United States Department of the Interior

BUREAU OF LAND MANAGEMENT

RE: Minor Modification to the Skyline Mine No. 3 - Relocating Setup Room and Bleeder Entries for the 5th Right Longwall Panel

ENCLOSURE 1

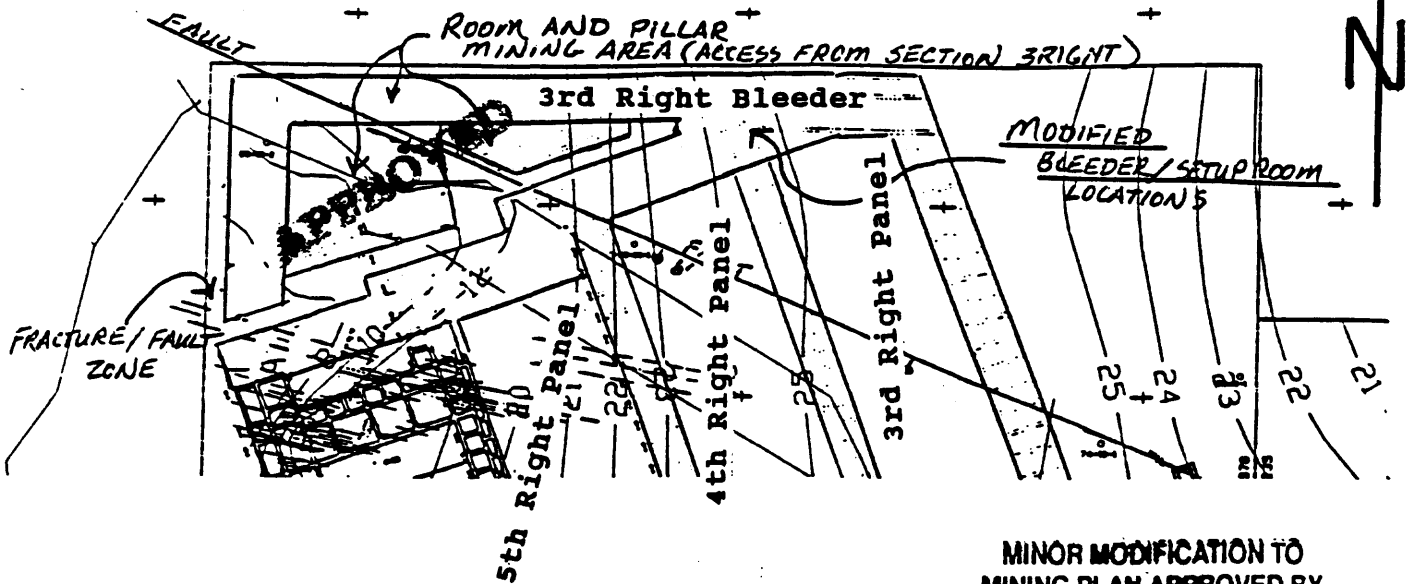
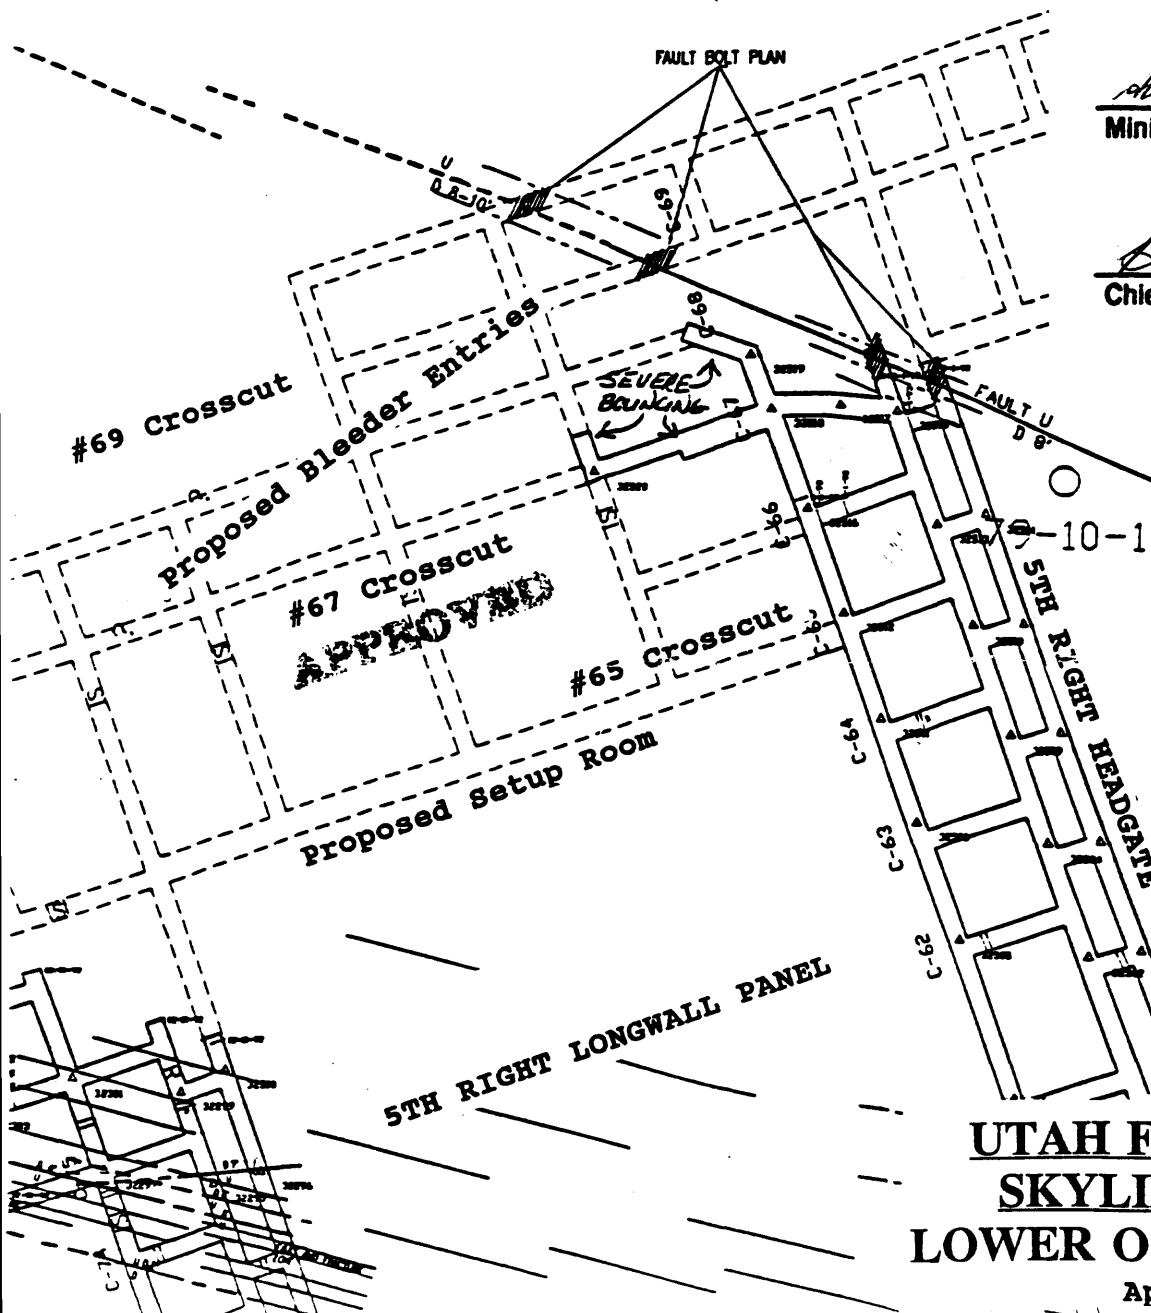
The approved mining plan was to develop setup room and bleeder entries for the 5th Right longwall panel between #69 and #71 crosscuts of the 5th Right Headgate (see Enclosure 1). UFC is now proposing to develop the setup room and bleeder entries between #65 and #68 crosscuts. UFC also proposes to mine the block of coal between #68 and #71 crosscuts from the 3rd Right bleeder entries utilizing room-and-pillar mining practices (see Enclosure 2).

According to UFC, the 5th Right Headgate in the Skyline Mine No. 3 has encountered a fault with a highly fractured zone. The fault would cross through the originally planned setup room for the 5th Right longwall panel. Unstable roof and unexpected high stress conditions encountered in the vicinity of this fault preclude the development of the setup room which requires an entry width of 28 feet.

Based on the BLM's observations in the mine, the fault will intersect the originally planned setup room for the 5th Right longwall panel. Developing the setup room and bleeder entries in the vicinity of this fault could trigger additional bouncing which would seriously endanger employees and mining equipment. In addition, the 28 feet required for the setup room will further de-stabilize the roof. Recovering the remaining reserves in this block with a continuous miner from the 3rd Right bleeder entries will result in maximum coal recovery.

Therefore, the BLM authorizes UFC to develop the setup room and bleeder entries for the 5th Right longwall panel between #65 and #68 crosscuts of the 5th Right Headgate as requested. This confirms the verbal approval given to Utah Fuel Company personnel on May 17, 1993. In addition, UFC will develop (first mining only) the remaining reserves in the block of coal between #68 and #71 crosscuts from the formerly approved 3rd Right bleeder entries by room-and-pillar mining methods. The modified plan will reduce the recoverable coal reserves in this section of the mine by 40,000 tons.
